PONTIAC

Service Craftsman News

No. 11 S-289

December, 1956

Fig. 2 Strato-Flight Torque Wrench Extension J-6498

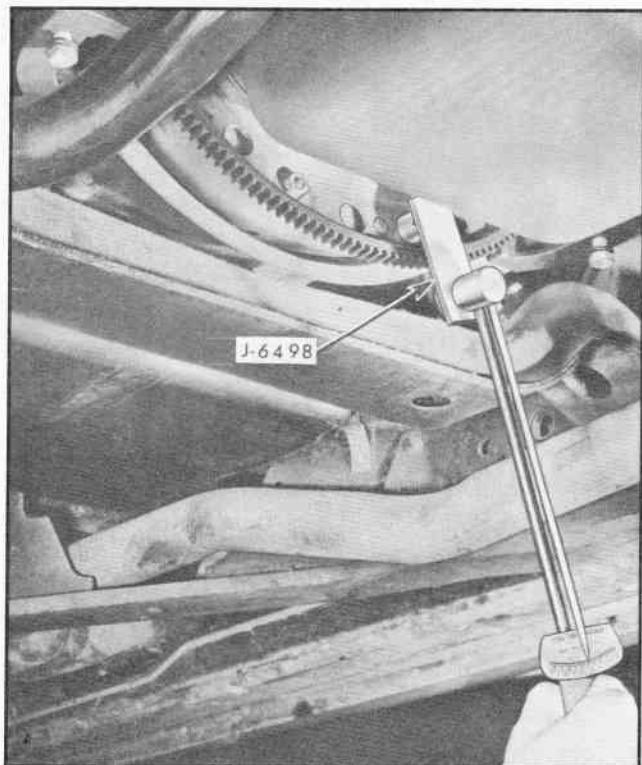
The Strato-Flight Torque Wrench Extension is included in the 1957 Pontiac Essential Service Tools Package to aid in properly tightening the bolts which attach the flex plate to the torus cover and flywheel (Fig. 2). Because of insufficient clearance between the flex plate and the engine oil pan, a standard socket attached to a torque wrench cannot be used for this operation. The extension makes possible the use of a standard socket for tightening these bolts. This tool readily adapts the proper 3/8" socket to any 1/2" Drive Torque Wrench.

In order to prevent stripped bolts or damage to the flywheel or flex plate, a new torque specification of 15 lb. ft. has been established.

Fig. 4 Cross Section of Tubeless Tire and Rim

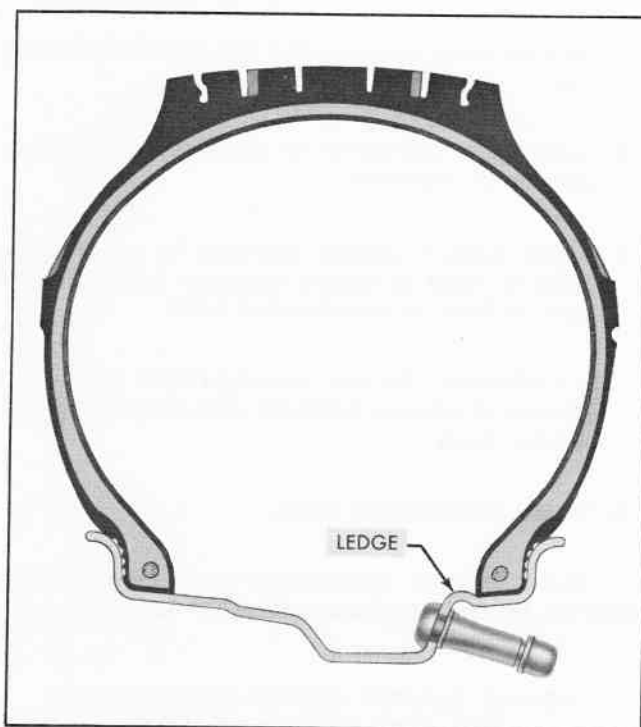
The 1957 wheel assembly has a ledge-type bead seat on the outboard (valve hole) side of the rim (see Fig. 4). This design provides a tight tire fit making it necessary to use a rubber lubricant such as Ru-Glyde or a vegetable oil soap solution for tire mounting and dismounting. This design also makes it mandatory that the tire mounting and dismounting are done with the outboard (valve hole) side of the wheel up.

Fig. 5 Identification of Spacer-Channel Plate to Case

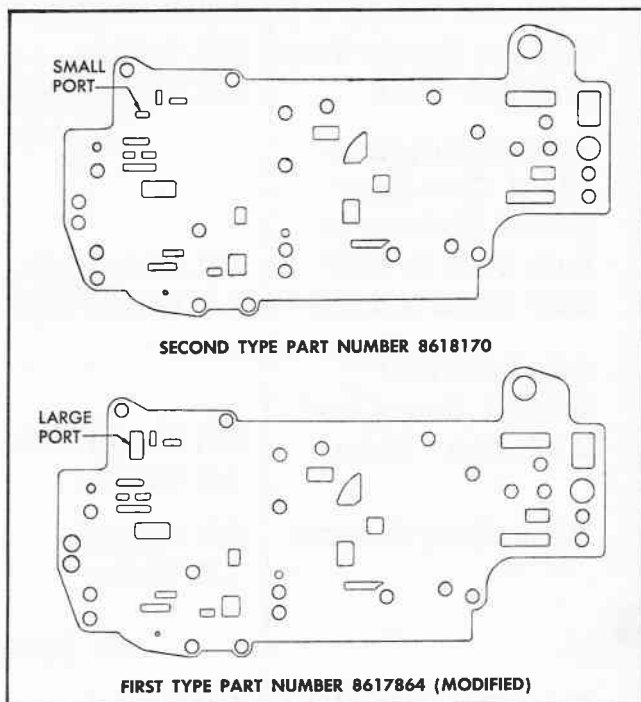
A change has been made in the 1957 Strato-Flight manual valve body and the channel plate-to-case spacer. The second type has a revised exhaust for neutral clutch apply oil in "Reverse". The difference between the first and second type 1957 channel plate-to-case spacers can be seen in Figure 5.

While the change in the manual valve body is difficult to recognize, the spacer plate can be identified to determine whether a control valve assembly has the first or second type manual valve body and spacer plate.

Only the second type parts will be serviced. The second type spacer plate can be used with either manual valve body. When installing a new manual valve body assembly, however, it is absolutely necessary that the second type spacer plate be used. The use of the second type manual valve body with the first type spacer would cause leakage of Lo Range oil resulting in failure of the Lo band.

Fig. 7 Power Window Jumper Harness Assembly

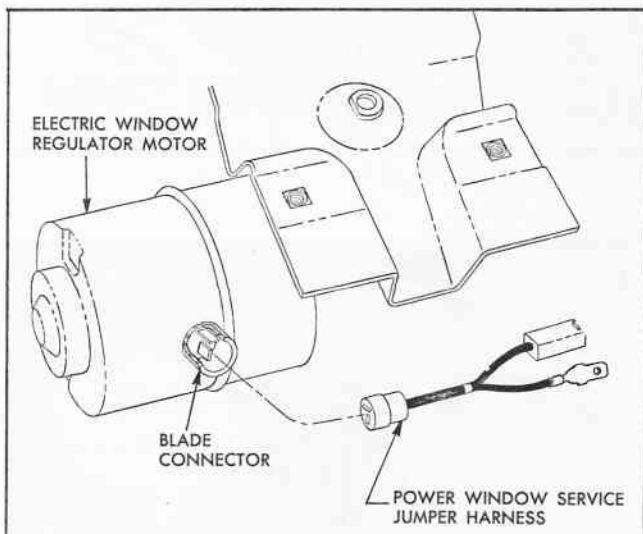
The 1957 Electric Window Regulator Motor can be installed on 1955 and 1956 models by using a newly developed Power Window Service Jumper Harness Assembly, part number 4712588. The 1957 motor incorporates a new socket and blade type connector attached directly to the motor case (Fig. 7). The Power Window Service Jumper Harness is designed to engage this blade type connector on the 1957 motors and has the necessary terminal and connector for connecting with 1955 and 1956 body wiring harness (Fig. 7).

Fig. 8 Evaporator Drain Tube Modification

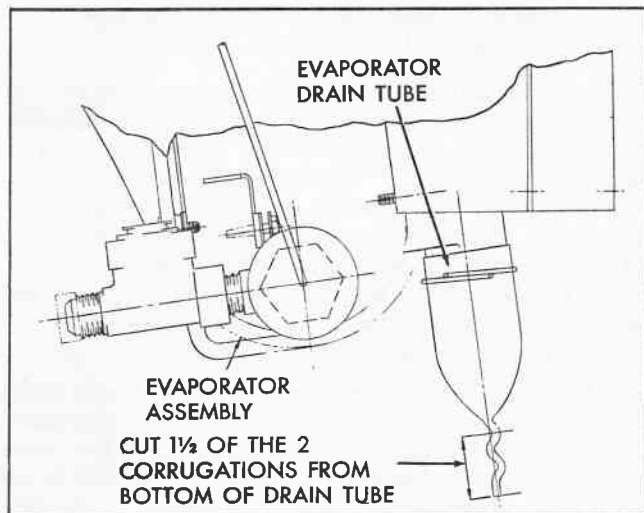
Under heavy rain conditions or when the car is being washed, the 1957 Air Conditioning Evaporator will not discharge water rapidly enough through the Evaporator Drain tube, with the result that water fills up the Evaporator and floods over into the Blower Housing and down the face of the Dash Insulator on the inside of the car.

To correct this condition, cut off one and one-half (1-1/2) of the two corrugations from the bottom of the Evaporator Drain Tube (Fig. 8). This modification should be made at the earliest opportunity to forestall the condition and prevent any owner dissatisfaction.
